March 8, 2013

Re: Final Environmental Impact Report for the Los Angeles International Airport
Specific Plan Amendment Study - Comments of City of Inglewood, City of
Culver City, City of Ontario and County of San Bernardino

Figure 1a. Example EDMS (B747-400) Emission Rates by Operational Mode

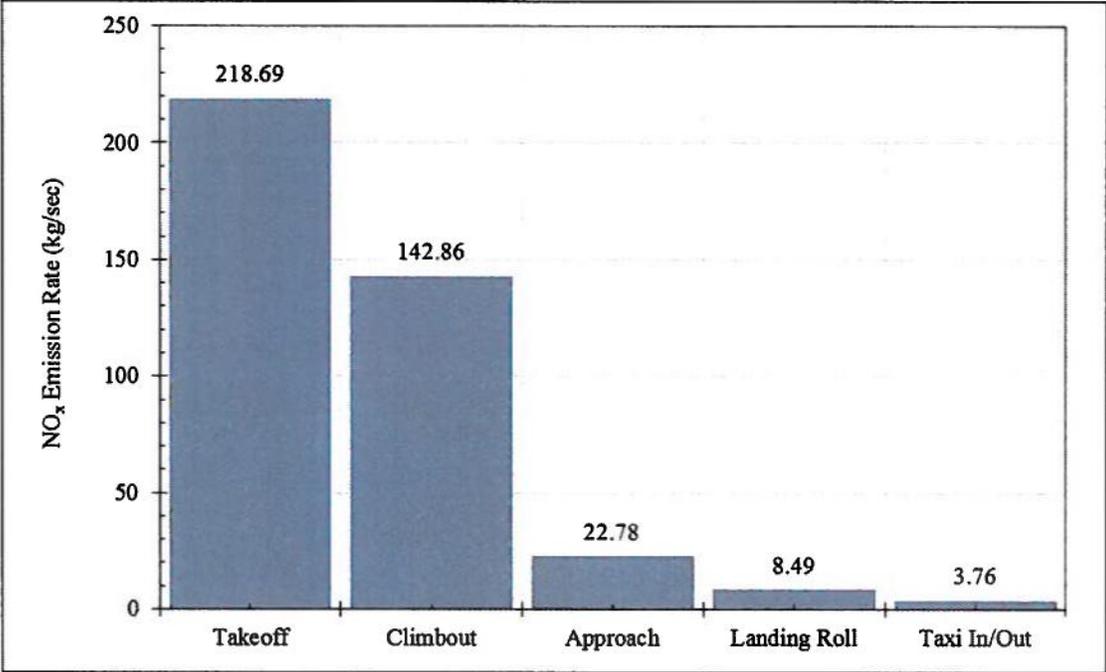
As expected, NO_x emissions are directly related to thrust, being highest during takeoff and declining with thrust through the other modes. The exception is for the landing roll operational mode within which the FAA (through the EDMS User's Manual) claims to include reverse thrust operations. Such operations are high thrust and should reflect a relatively high NO_x emission rate, similar in magnitude to that of takeoff and climbout operations.

For the B747, Figure 1a indicates that landing roll NO_x reflects nothing more than a power-down transition from approach thrust to engine taxi. It might be possible that the reverse thrust portion of the landing roll mode is simply being "averaged down" with non-reverse thrust portions of the same mode. Figure 2a and 3a, however, seem to indicate that this is not the explanation.

Figure 1b. Example EDMS (B737-800) Emission Rates by Operational Mode

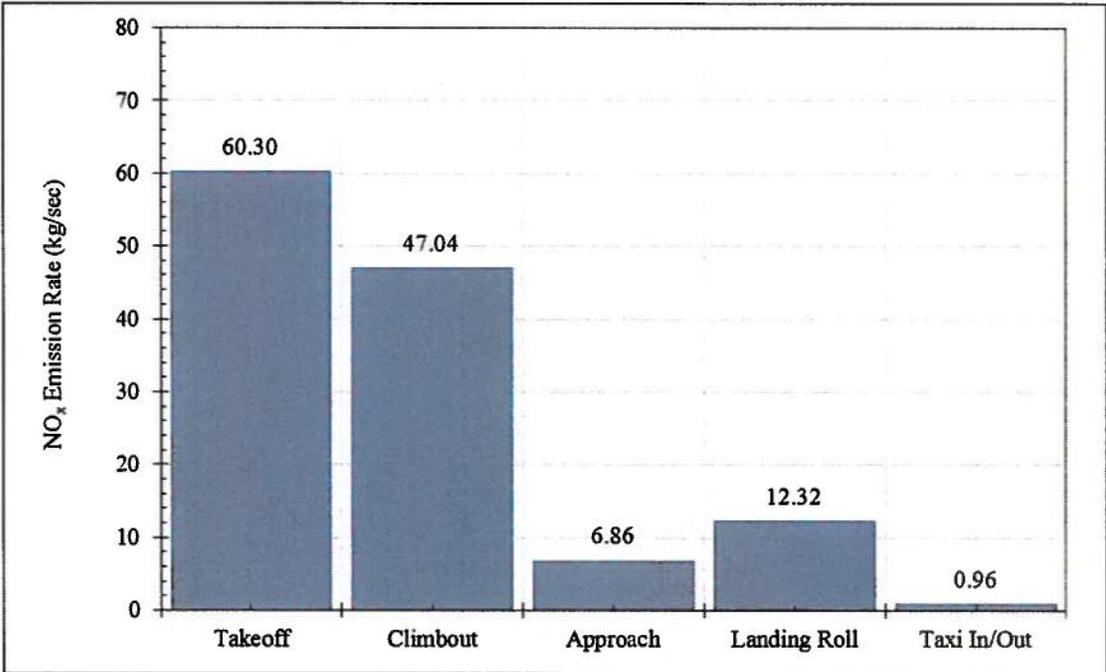
The results are somewhat different for the B737. Figure 1b demonstrates a minor increase in landing roll NO_x from approach thrust, but this increase is far lower than the high thrust operations that would normally be expected from reverse thrust.

Figure 2a. Example EDMS (B747-400) Operational Mode Durations

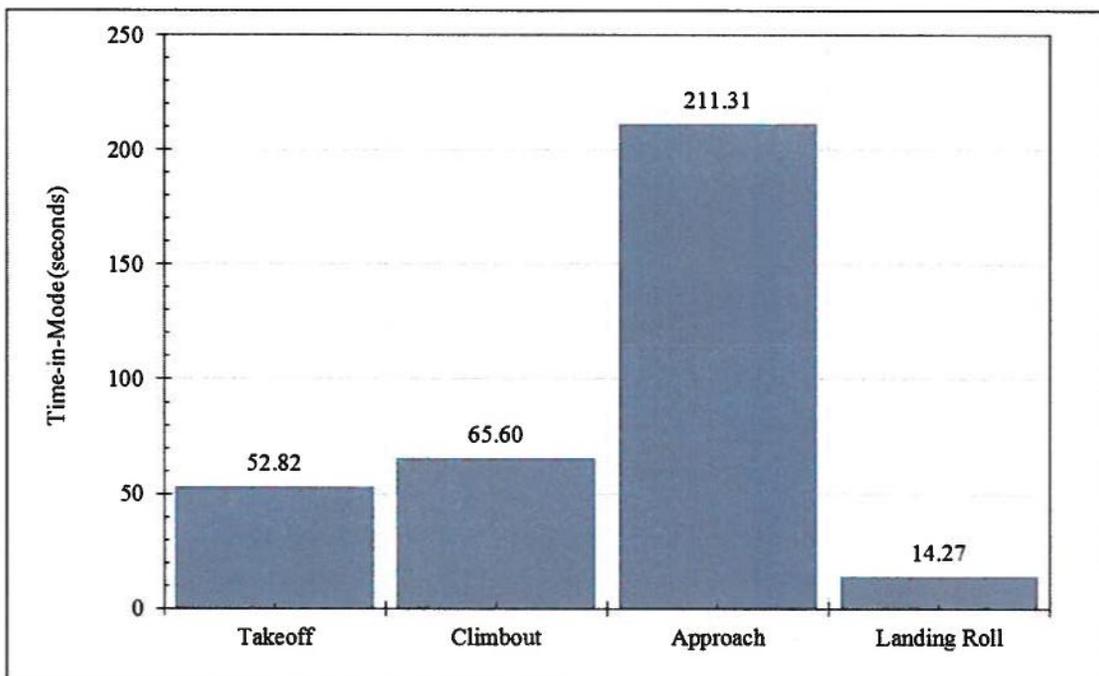
Figure 2a demonstrates that the duration of the entire landing roll operational mode is less than 15 seconds. The reverse thrust operation alone would generally endure for that entire period. Moreover, in Figure 3a, which depicts the second-by-second data for the aircraft operating modes, the transition from approach to landing roll operations clearly reflects the absence of any NO_x spike of any duration associated with the B747 landing roll.

Figure 2b. Example EDMS (B737-800) Operational Mode Durations

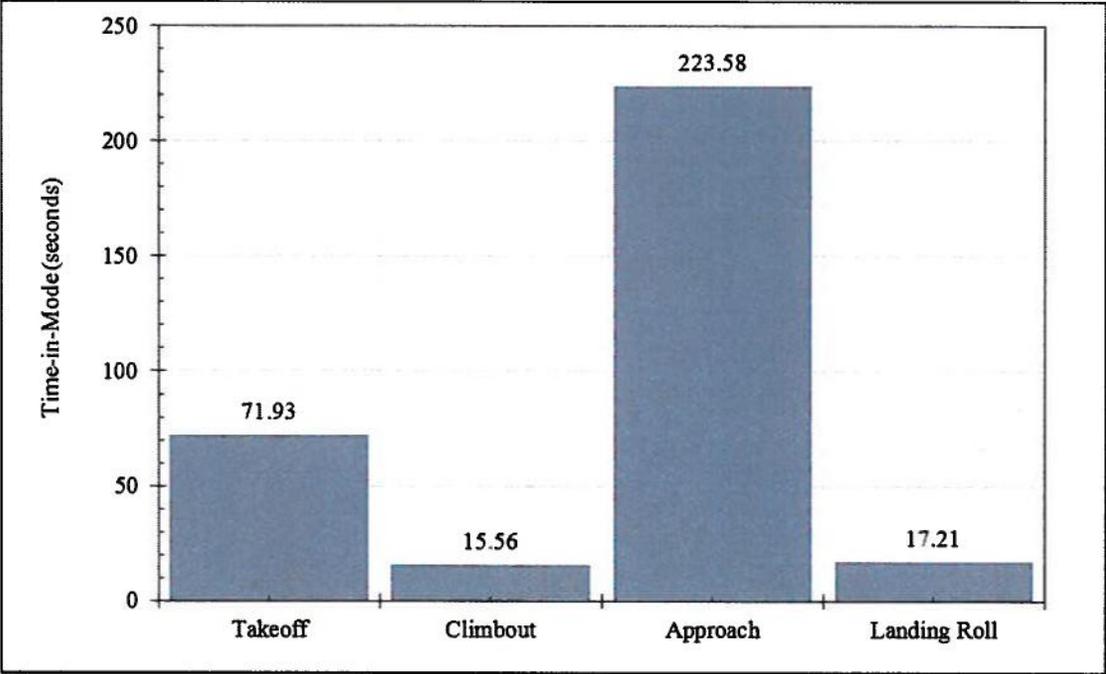
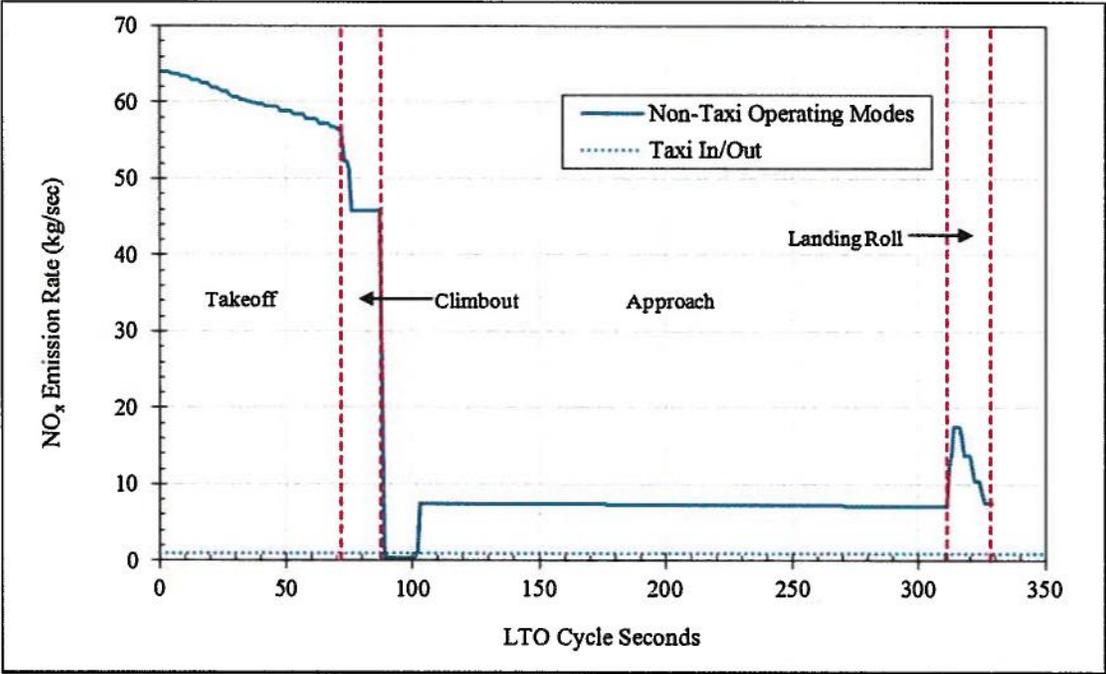
Figures 2b and 3b show that, as was the case for the B747 example, the “muted” effect does not result from any landing roll averaging. In fact, the thrust increase is fairly constant across the complete 17 second landing roll, as depicted in Figure 4b.

Figure 4a. Example EDMS (B747-400) Relative Thrust (as NO_x) by Mode

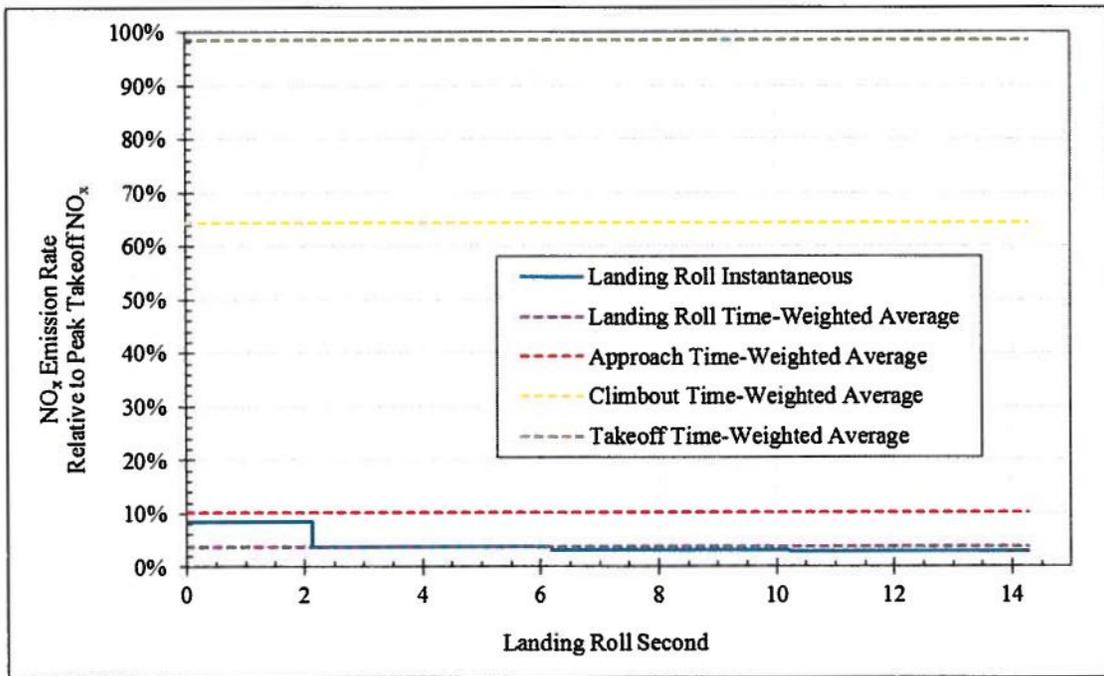
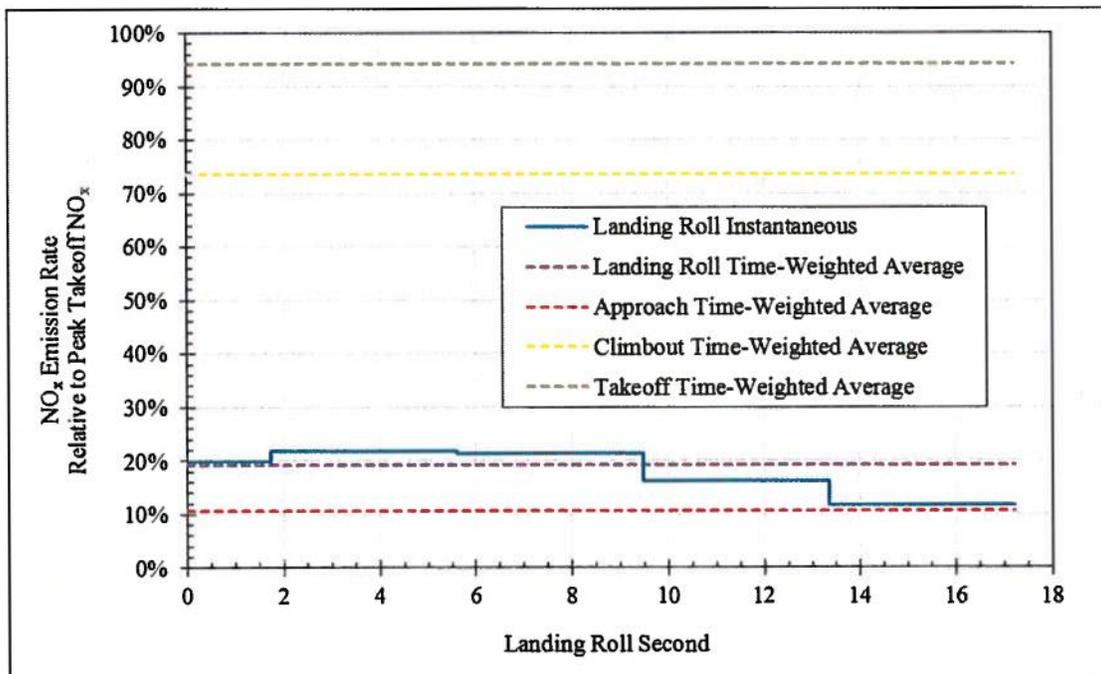
Figures 4a and 4b summarize the example results in terms of relative NO_x emissions rates across the four non-taxi operating modes. For these figures, mode specific NO_x is compared to peak takeoff NO_x on the premise that NO_x emissions rates are a reasonable surrogate for engine thrust conditions. As expected, takeoff and climbout thrusts are significant fractions of peak takeoff thrust. For the B747, Figure 4a demonstrates no reverse thrust operation during the landing roll. For the B737, Figure 4b, landing roll thrust is increased as would be expected during reverse thrust operations, but by a relatively modest amount.
